Compatibility LMK 3005 / LMK 3010 to predecessor

Customer information #10/2016

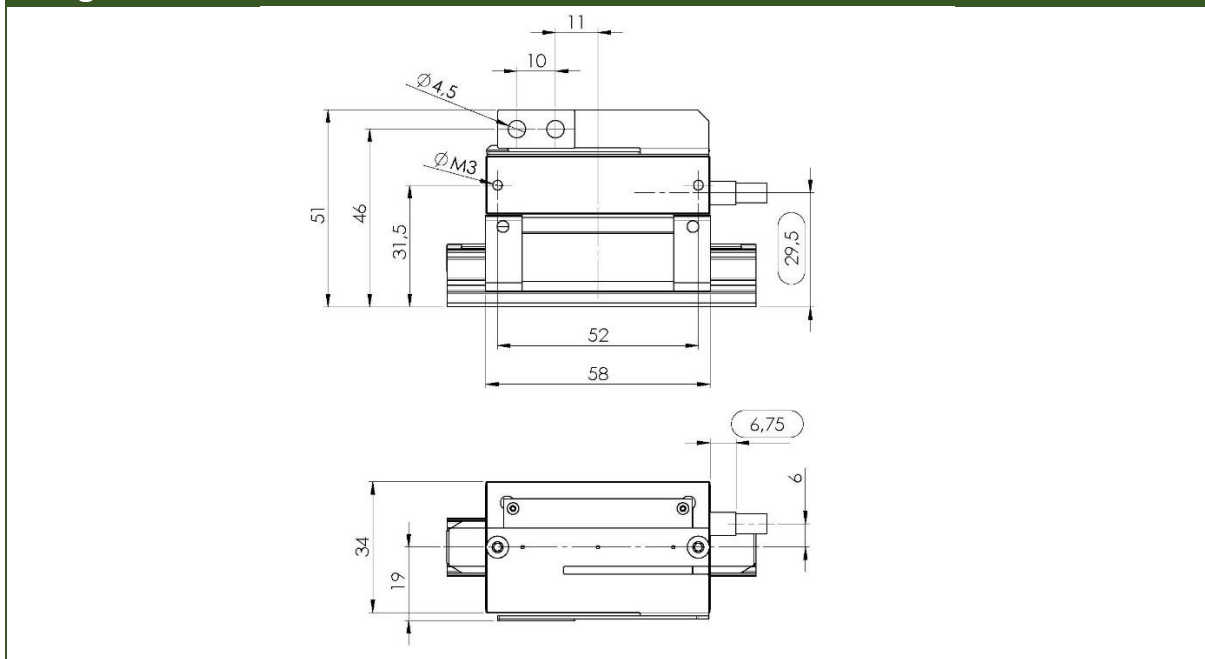
Angle encoders with TTL Interface and an interpolation factor of 1000 (which means a resolution of 0,25µm arc length based on a grating period of 1000µm) won't show up any more as a price list device.

But there is a backward compatible version available to continue existing applications.

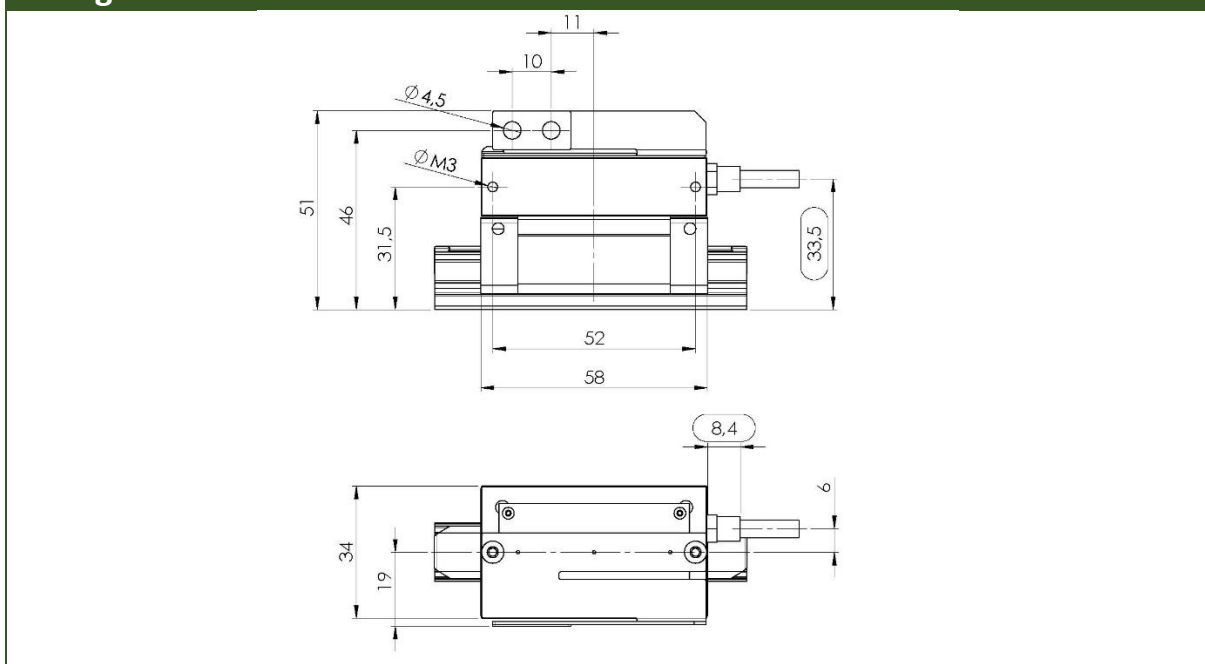
The mechanical dimensions are identical except an improved cable gland (optimizing EMI behaviour) compared to the previous version.

Mechanical dimensions shown in the following drawings. Differences in mechanical dimensions are indicated.

old generation

new generation
